**CITY OF PORTLAND, MAINE
DEVELOPMENT REVIEW APPLICATION
PLANNING DEPARTMENT PROCESSING FORM**

Maggie Lane lot 12

RE: Response to your comments on lot # 12 Maggie Lane

RE: DAN - THE LOT #12 PLAN SUBMITTED TO YOU
ON 11-7-00 DOES NOT ADDRESS ANY OF THE POINTS
OUTLINED IN MY LETTER THAT WAS FAXED TO
YOU ON 11-1-00. (ATTACHED) SUBMIT A PLAN
THAT ADDRESSES THESE ISSUES. ALSO SUBMIT A
PLAN THAT IS TO SCALE. RIC

Drawing Name: Space & Bulk Requirements Lot 12
Project: MAGGIE LANE, PORTLAND

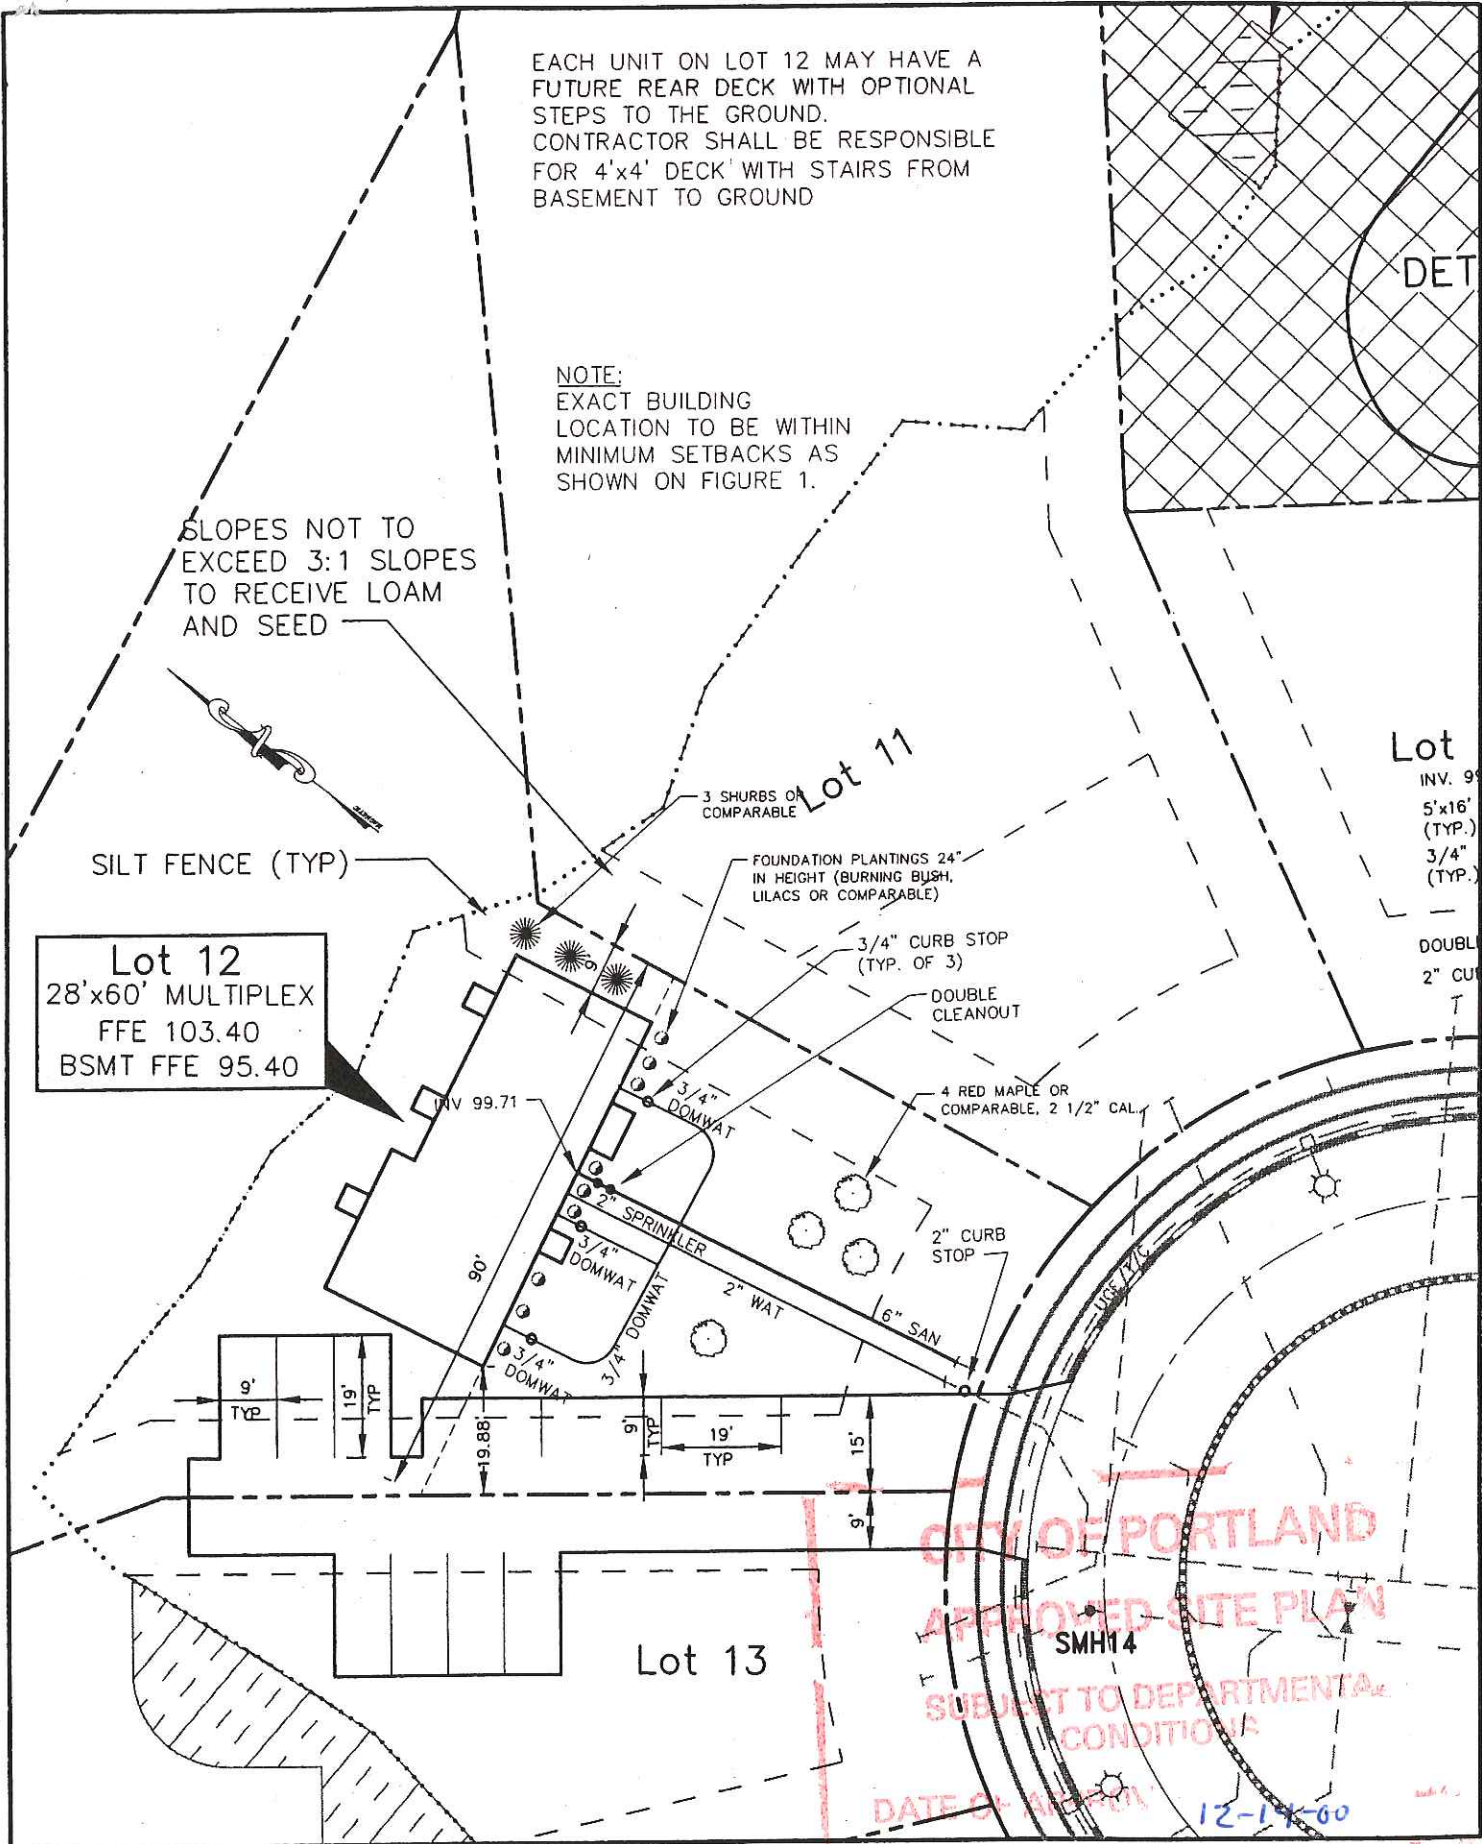
3. INDICATE INSTALLATION OF A SILT FENCE UPGRADE FROM THE WETLAND PRIOR TO CONSTRUCTION.
4. MARCO INDICATED THAT THE BUILDING IS 2 1/2 STORIES HIGH, THEREFORE YOU NEED SIDERYARD SETBACKS OF 14 FEET AND 14 FEET. A REMINDER THAT THE 90 FOOT LOT WIDTH NEEDS TO BE MAINTAINED. SHOW THE SETBACKS IN FEET.

3. The silt fence is in place, but we will add it to the site plan.
4. The set back issues have been addressed with Marge at my meeting with her last week. There is a 12' setback because less then $\frac{3}{4}$ of the building is daylight walls, if more then $\frac{3}{4}$ was daylight then it would have been 2.5 stories.

Drawing Name: **Layout & Utilities-Lot 12 & 13**
Project: **MAGGIE LANE, PORTLAND**

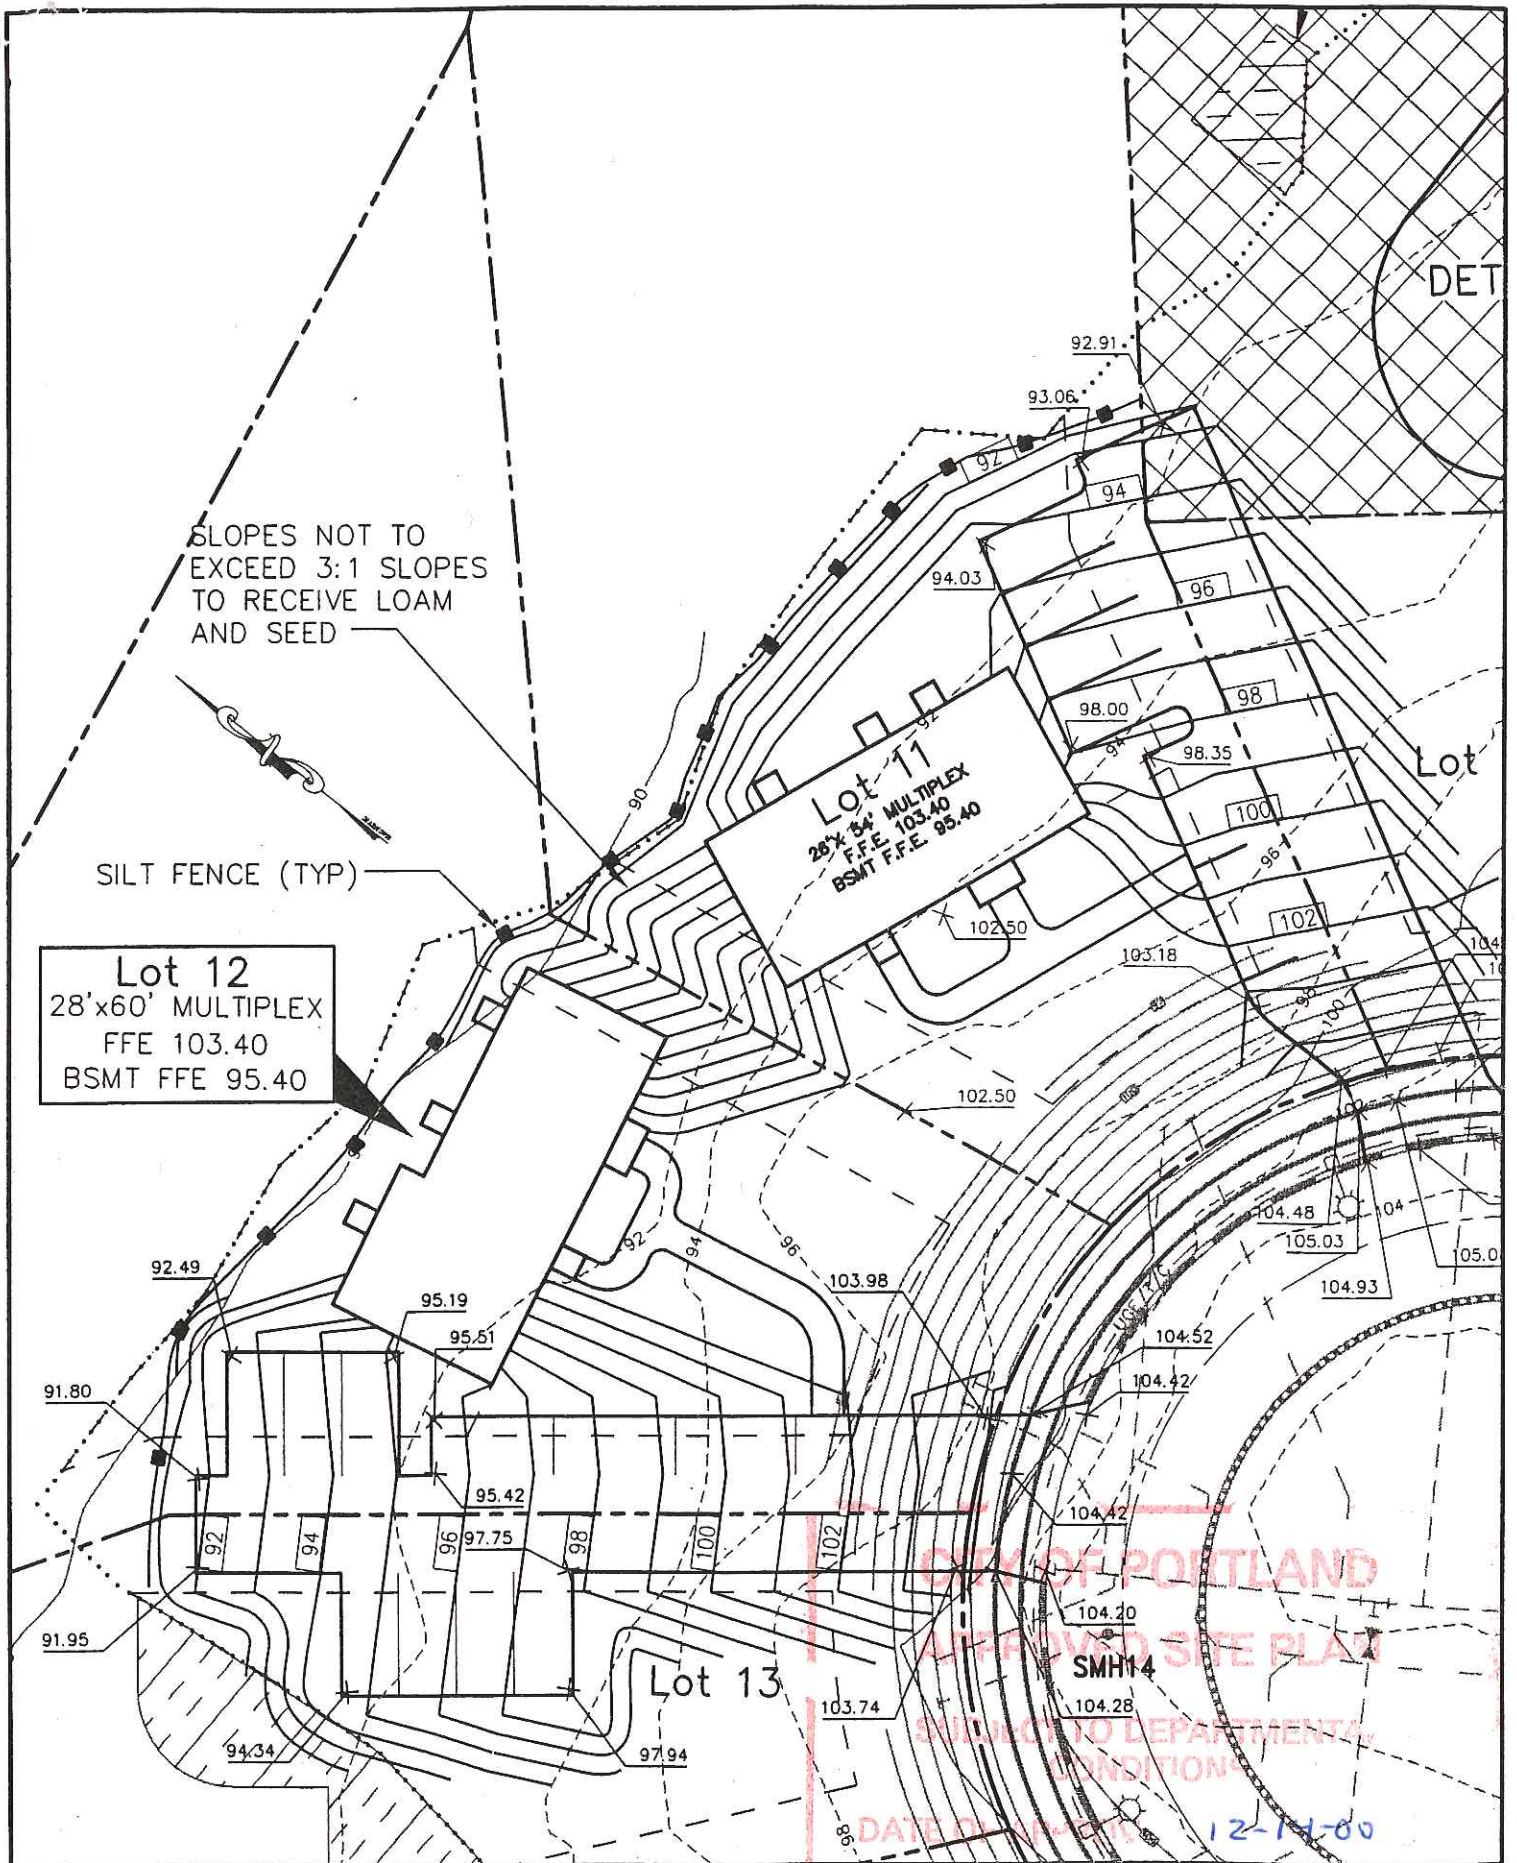
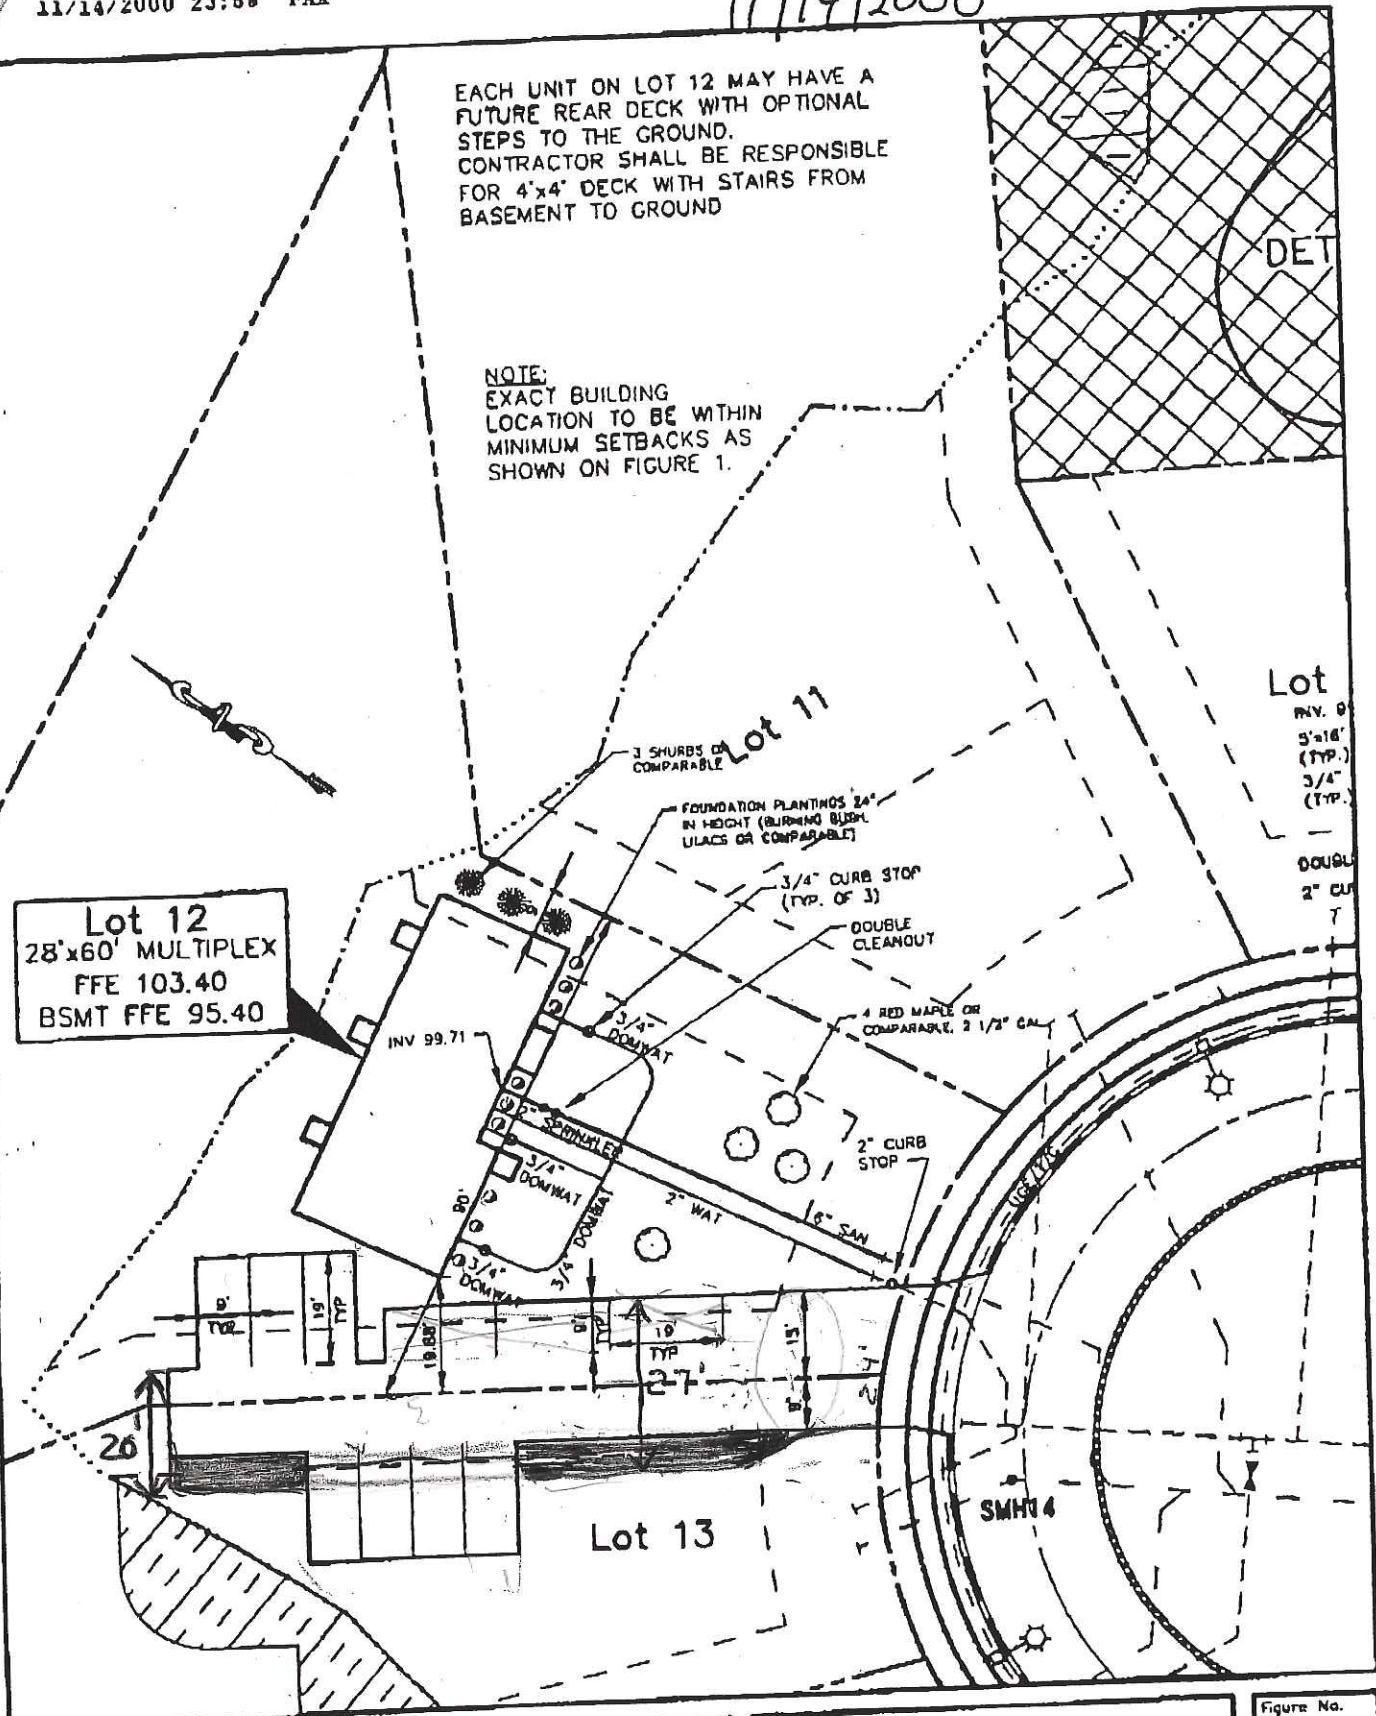
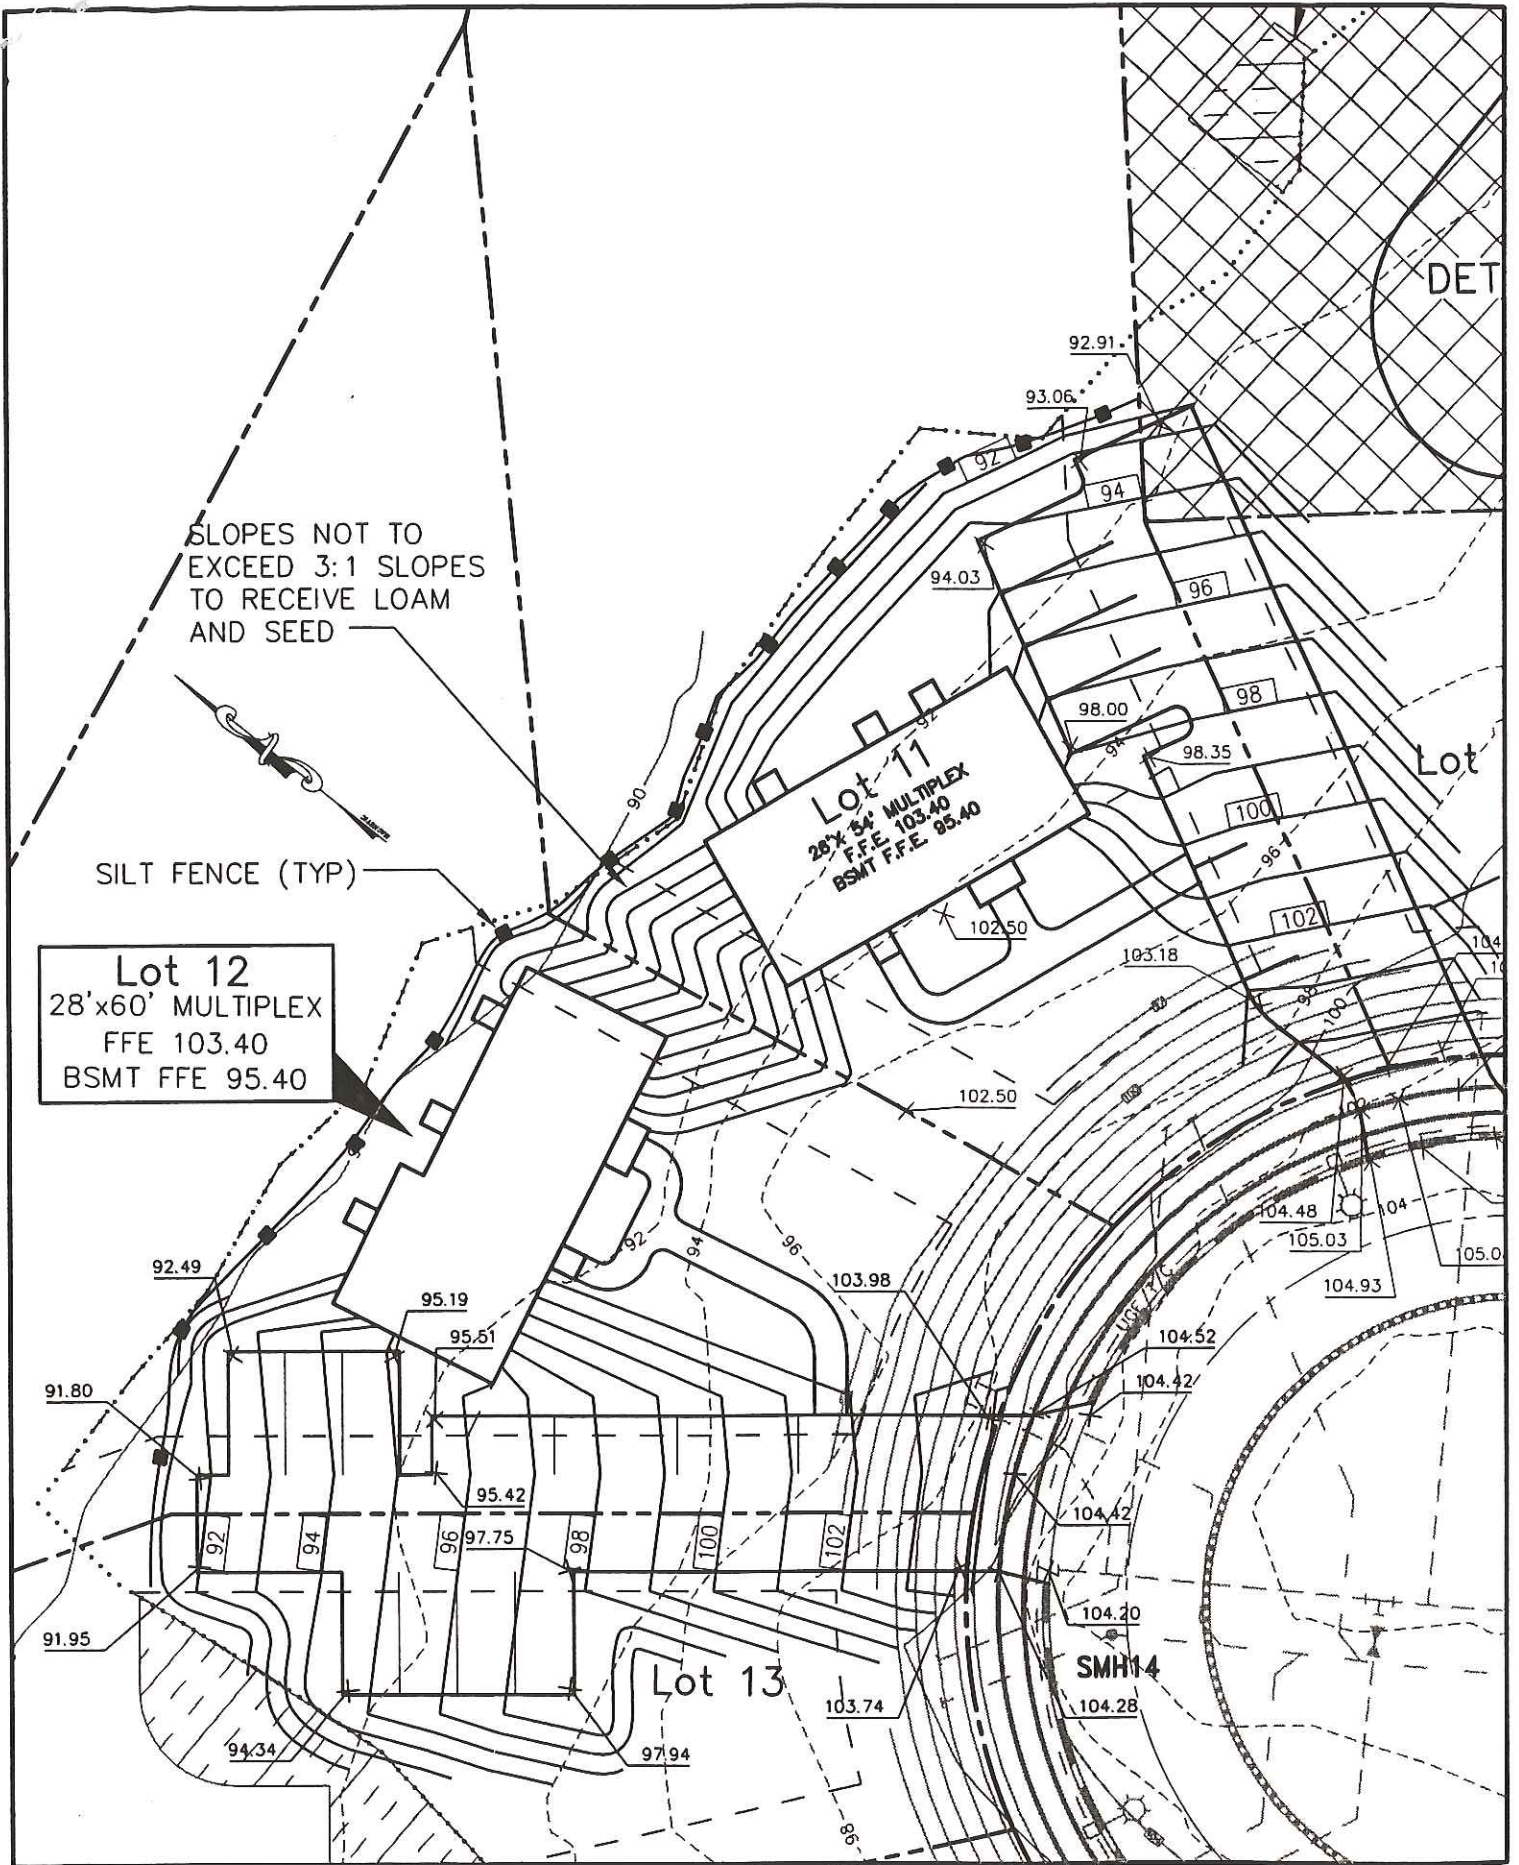
1. SITE PLAN SHOULD SHOW THE DECK FOOTPRINTS AND BACK STAIRWAYS. THERE IS A SIGNIFICANT 5 FOOT DROP FROM THE FLOOR TO THE GROUND. STAIRS ARE A CODE REQUIREMENT.

6. THIS IS A BIG BUILDING; NEED 9 FOUNDATION BUSHES ALONG THE FRONT FOUNDATION, ALSO AN ADDITIONAL DECIDUOUS TREE NEEDS TO BE PLANTED IN THE FRONTYARD BETWEEN THE DRIVEWAY AND ON-SITE WALKWAY.

1. The decks and stairs have been added to the site plan.
2. Gorrill-Palmer & Steve Bushy from Deluca - Hoffman, both agree that RipRap is an acceptable slope stabilization measure. There is no way to get a 3 to 1 slope with a 12' drop over 24'. Both the Buyers for lots 11 & 12 do not want retaining walls between buildings for liability and maintenance reasons. If we bring the slopes out past the front of the Buildings the sides would have to become a daylight basement, this would effect our building envelope, grading and final appearance that the purchasers are looking for. We have been patient with this process but we feel it is putting extra burden and is unreasonable to force the purchasers into something they do not want.

5. We will ad an extra window per your request. This will be done in the field and can be part of your C. O. Approval.
6. Extra bushes will be added, we have already escrowed \$2,000 with the city for final site work completion.
